**AIP SUPPLEMENT
(SUP)****AIRAC****H93/26****Effective: 202608051600 UTC**

GOLD COAST AERODROME (YBCG) RNP Y RWY 14 (AR) AMENDMENT

APPENDIX 1 TO SUP H93/26

RNP Y RWY 14 (AR)
GOLD COAST, QLD (YBCG)

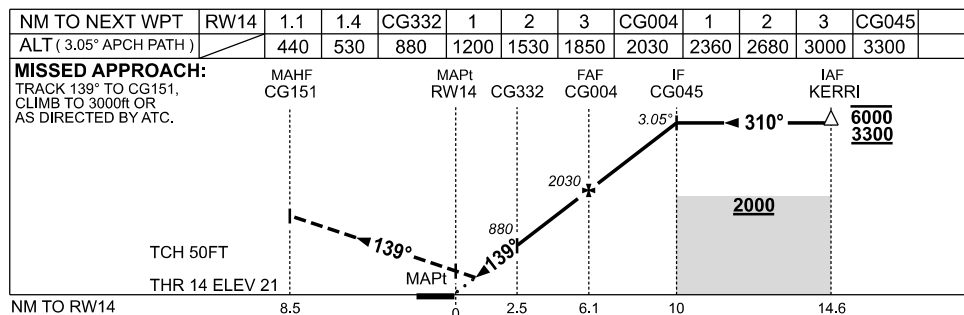
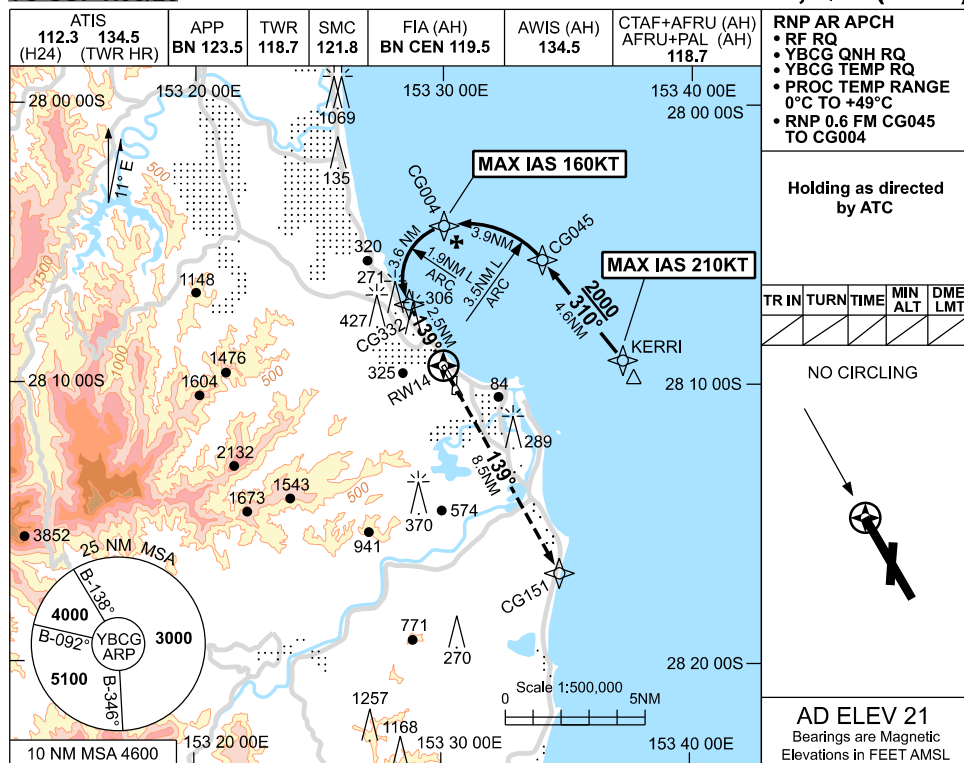
- 1.1 This SUP implements an amendment to the RNP Y RWY 14 (AR) procedure.
- 1.2 RNP Y RWY 14 (AR) approach procedure amended to RNP 0.6 between CG045 and CG004.
- 1.3 Recommended coding for this procedure is available on request.

Changes: RNP 0.11 MINIMA, RNP VALUE IN INTERMEDIATE SEGMENT, Editorial.
